Urban Transportation Plan Amendment: Norchester/Acushnet Drive Extensions

Planning Commission Presentation
February 22, 2017

Proposed UTP Map Amendment

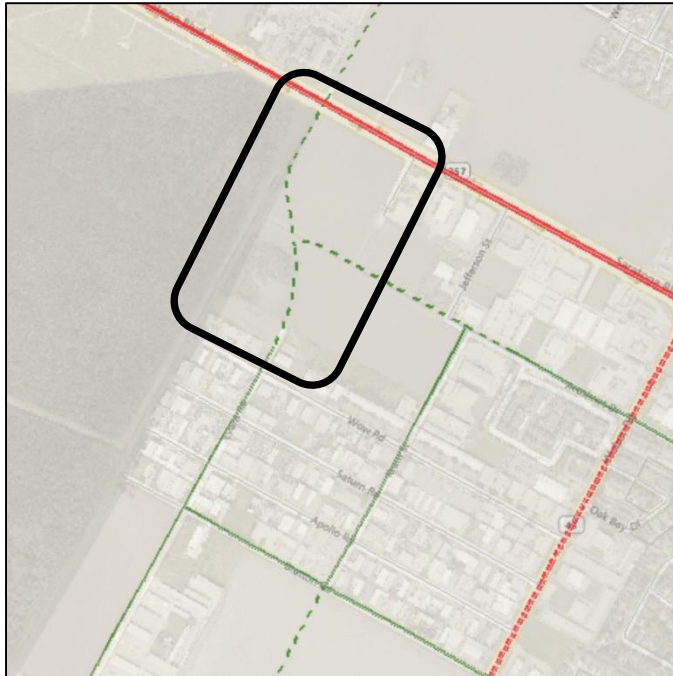
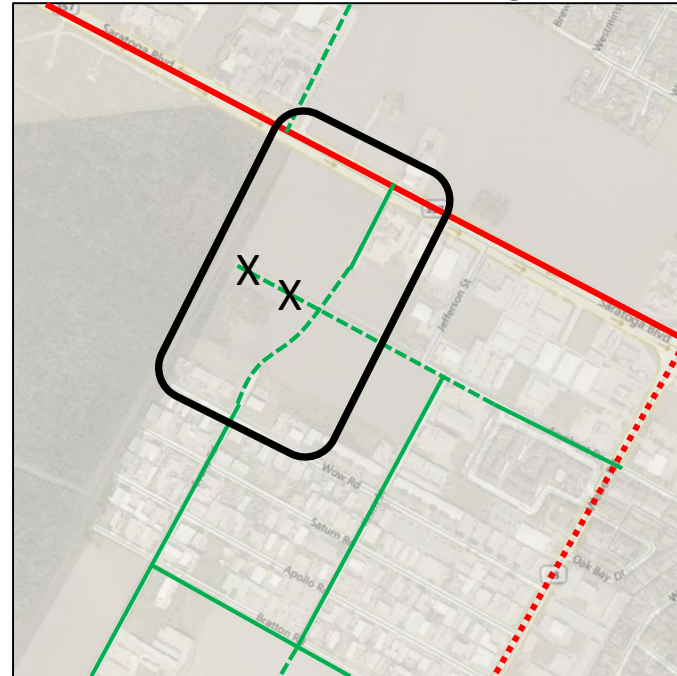
- Realigns a proposed C1 Collector from Norchester Dr. to Zenith Dr.
- Permits Future Signalization (T-intersection) on Saratoga Blvd.
- No Requirement to Request Additional ROW from Federal Government
- Maintains Connections to Saratoga Blvd. and Acushnet Dr.
 - Extension of Zenith Dr. (South to Evans Rd.)
 - Extension of Acushnet Dr. east of Zenith Dr./Evans Rd.
 - ~~Extension of Acushnet Dr. (To West Property Line)~~

- Transportation Advisory Committee (TAC)
Recommendation:
 - Delete Segment of Proposed C1 Collector Along West Property Line (Utilize Zenith Dr., 60' ROW)
- Staff Recommendation:
 - Approval of the UTP amendment as shown
